NEWCASTLE LANDING SUBDIVISION

APPLICATION NUMBER 6 DATE November 4, 2010
 APPLICANT Newcastle Landing Subdivision
 REQUEST Subdivision

DETAIL SITE PLAN

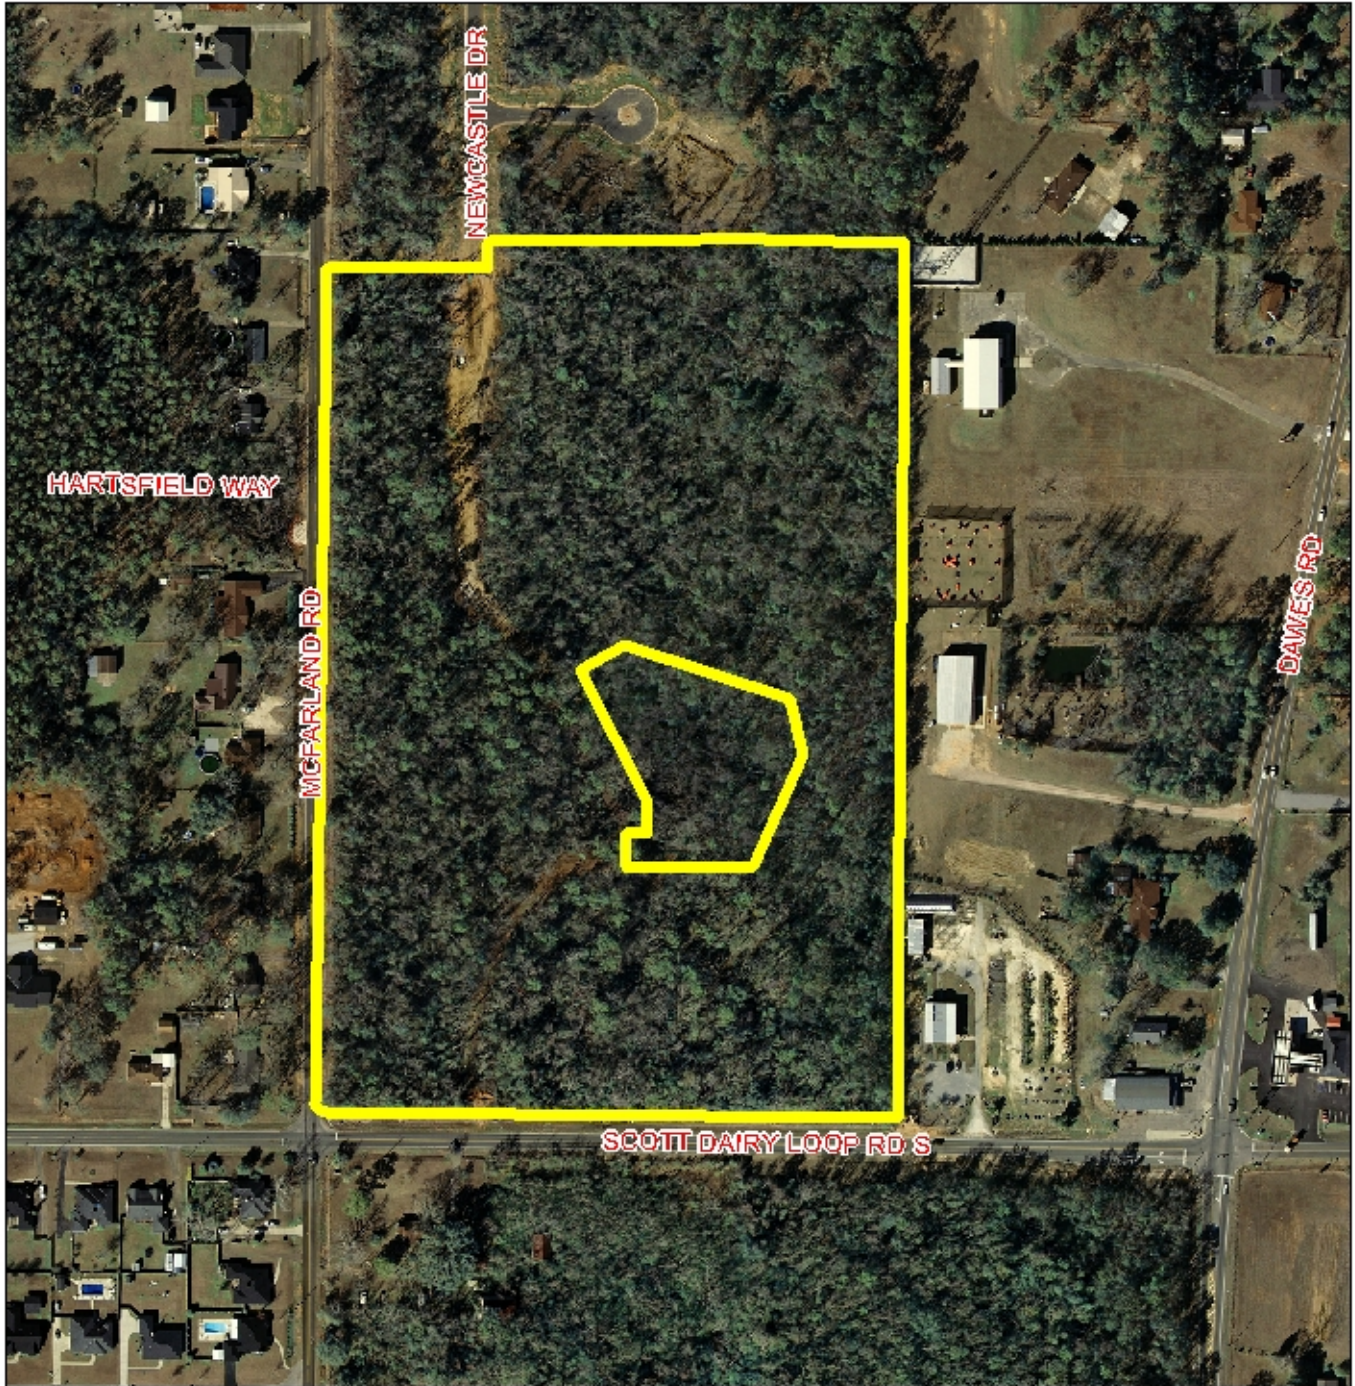
This subdivision will require the construction of streets to Mobile County standards, and all new street rights-of-way, as depicted, meet to requirements of Section V.D.14. of the Subdivision Regulations. Cul-de-sacs without medians are shown to have a compliant 120' diameter on the plat. As a means of access management, a note should be required on the final plat stating that

Lots 1 through 13 are denied direct access to McFarland Road, and Lot 14 is denied direct access to both McFarland Road and Scott Dairy Loop Road South. Also, a note should be required stating that Lots 15, 47 and 51 are denied direct access to Scott Dairy Loop Road South. A note should also be required on the final plat stating that all lots are limited to one curb cut each, with the size, location and design to be approved by County Engineering and conform to AASHTO standards.

The proposed subdivision has closed-end (cul-de-sac) streets over 600' in length which is the maximum length ordinarily allowed by Section V.B.6. of the Subdivision Regulations. However, due to the site constraints of topography and the common areas, a waiver of Section V.B.6. would seem in order.

As on the preliminary plat, the 25' minimum building setback line along all interior street frontages should be illustrated on the final plat. The plat should be revised to also illustrate a 25' minimum building setback line along both McFarland Road and Scott Dairy Loop Road South. And the plat should be revised to label each lot with its size in both square feet and acres, or a table should be furnished on the final plat providing the same information.

The plat indicates common areas labeled as such and an entrance median on Scott Dairy Loop Road South which should also be labeled as a common area on the final plat. A note should be required on the final plat stating that the maintenance of all common areas is the responsibility of the property owners and not Mobile County. A marshy area may be present within the existing recorded common area which indicates that the area may be environmentally sensitive; therefore, the approval of all applicable federal, state and local environmental agencies would be required prior to the issuance of any permits or land disturbance activities.

- 1) placement of a note on the final plat stating that Lots 1 through 13 are denied direct access to McFarland Road;
- 2) placement of a note on the final plat stating that Lot 14 is denied direct access to both McFarland Road and Scott Dairy Loop Road South;

- 3) placement of a note on the final plat stating that Lots 15, 47 and 51 are denied direct access to Scott Dairy Loop Road South;
- 4) placement of a note on the final stating that all lots are limited to one curb cut each, with the size, location and design to be approved by County Engineering and conform to AASHTO standards;

- 5) illustration of the 25' minimum building setback line along all interior street frontages and along McFarland Road and Scott Dairy Loop Road South;

- 6) labeling of each lot with its size in both square feet and acres, or the furnishing of a table on the final plat providing the same information;
- 7) revision of the plat to also label the entrance median on Scott Dairy Loop Road South as a common area;

- 8) placement of a note on the final plat stating that the maintenance of all common areas is the responsibility of the property owners and not Mobile County;
